Re: Environmental Assessment – Major Project Application MP09_0214
Concept Plan - Commercial and Retail Development at 177-199 Pacific Highway, North
Sydney

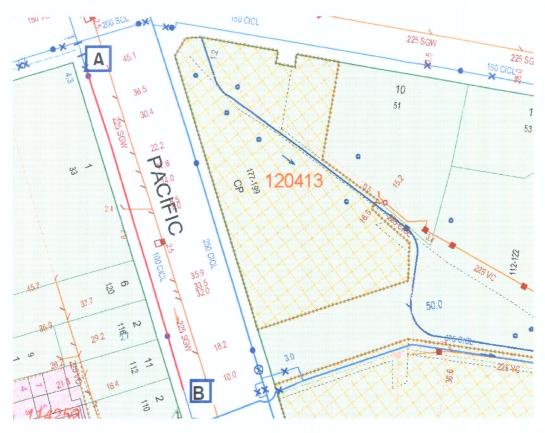
The 100mm drinking water main fronting the proposed development on the Pacific Highway does not comply with the Water Supply Code of Australia (Sydney Water Edition – WSA 03-2002) requirement for minimum sized mains for the scope of this development.

The drinking water main must be upsized to a 200mm from point 'A' to point 'B' ('B' is two metres beyond the point of connection) on the plan below.
